Reliability Analysis Update

Transmission Expansion Advisory
Committee
July 7, 2020

Dominion Cost/Scope Change

Penelec B2767 Scope Change

Existing b2900 Cost Increase and Scope Modification

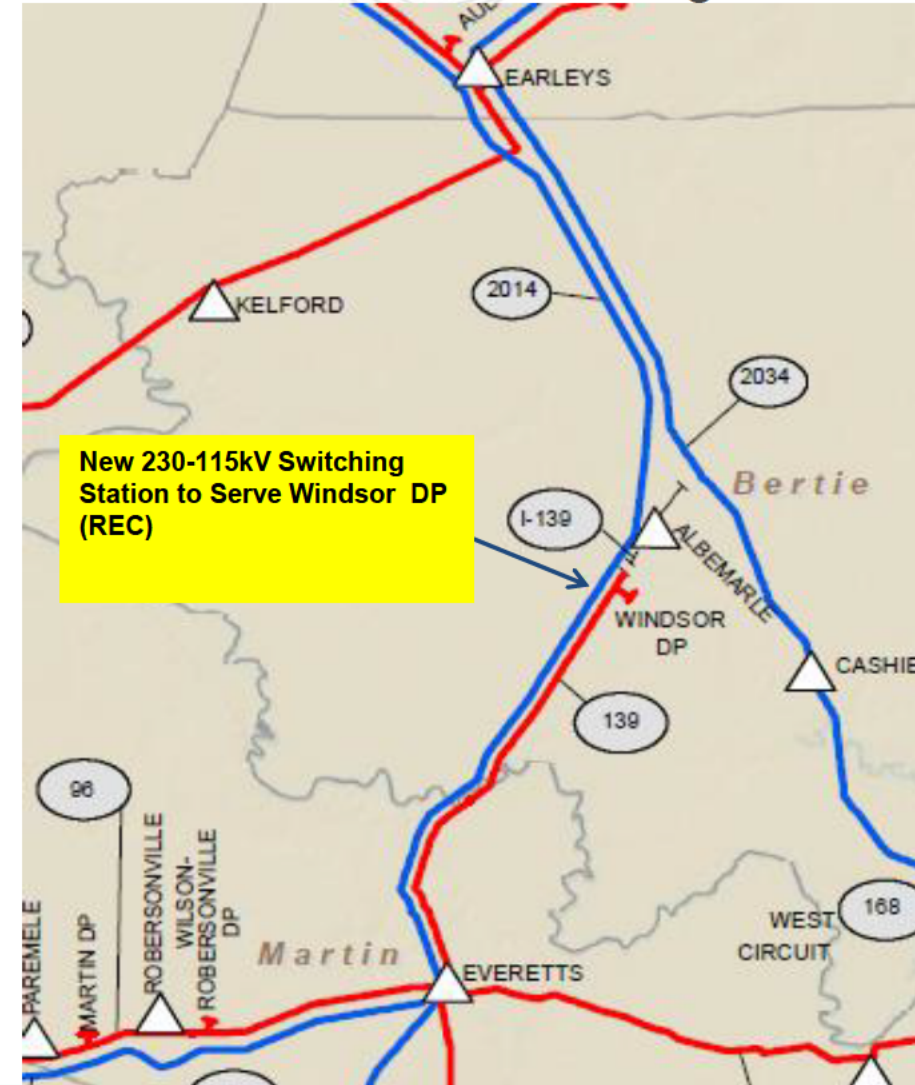
- 115kV Line #139 Everetts to Windsor has 336 ACSR conductor constructed on wood H-frames in the 1951 timeframe. Line #139 serves one delivery point Windsor DP (Roanoke EC). This line needs to be rebuilt to current standards or provide another source for Windsor DP based on Dominion’s “End of Life” criteria.
- Permanent MW load loss for removal of this line is 10 MW.

- Build a new 230-115kV switching station connecting to 230kV network Line #2014 (Earleys – Everetts). Purchase land and install three single phase 30 MVA 230-115kV transformers (and a spare) with a high and low side breaker. Provide a 115kV source from the new station to serve Windsor DP. Remove Line #139 19.5 miles (15.5 miles Everetts – Windsor, 1.1 mile Windsor to idle line, 2.9 miles idle line). **(b2900)**

- Build a new 230-115kV switching station connecting to 230kV network Line #2014 (Earleys – Everetts). Purchase land and install (2) three phase 84 MVA 230 -115kV transformers (one serve as a spare) with a high and low side breaker. Provide a 115kV source from the new station to serve Windsor DP. Remove Line #139 19.5 miles (15.5 miles Everetts – Windsor, 1.1 mile Windsor to idle line, 2.9 miles idle line).

- **Original Estimated Project Cost:** \$11.5 M
- **Revised Estimated Project Cost:** \$17.4 M **New**

B2767 Scope change:

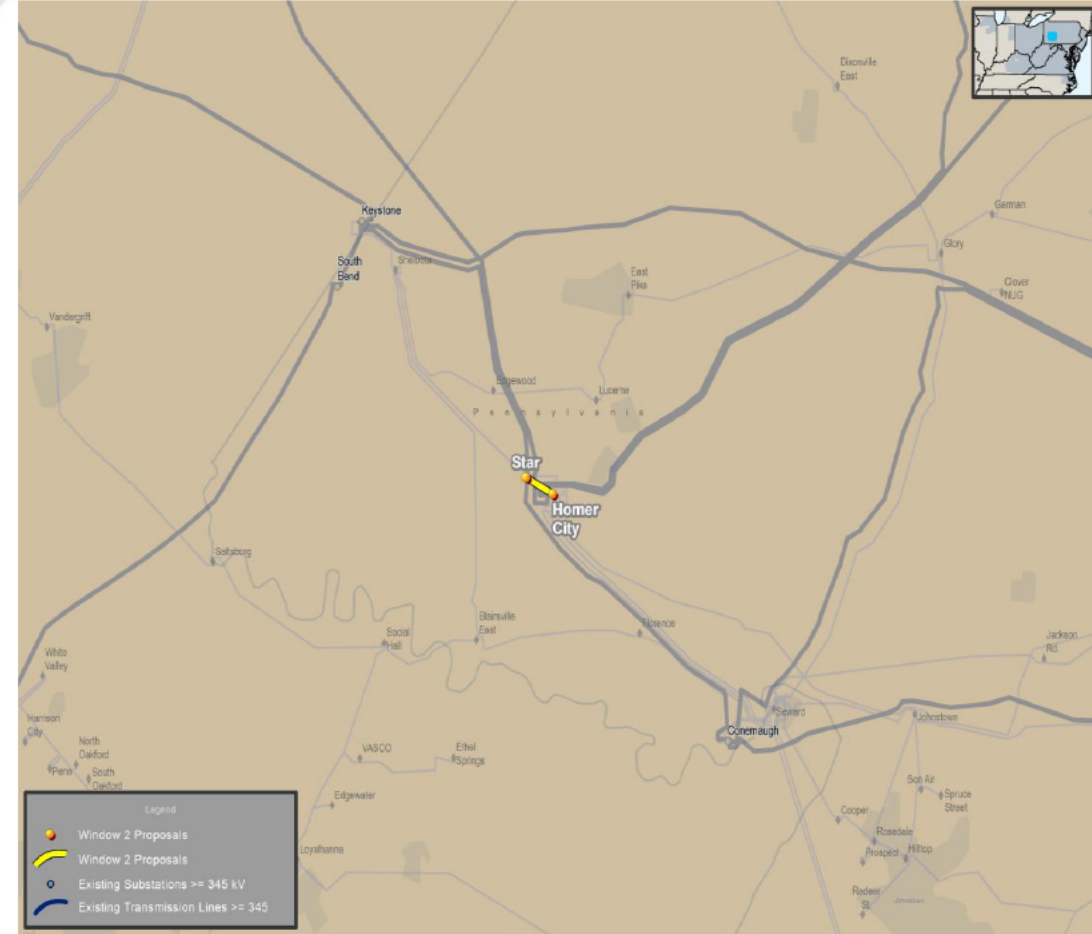
The Homer City 345/230 kV transformer “S” is overloaded for a line fault stuck breaker contingency loss of the Homer City – Armstrong 345 kV circuit and Homer City 345/230 kV transformer #N.

Construct a new 345kV breaker string with three (3) 345kV breakers at Homer City and move the North autotransformer connection to this new breaker string. (2016_2-8G)

Install one new 345 kV breaker and relocate the Homer City - Mainesburg 345 kV line terminal and Homer City 345/230 kV North transformer terminal

New Estimated Project Cost: \$ 7.0 M
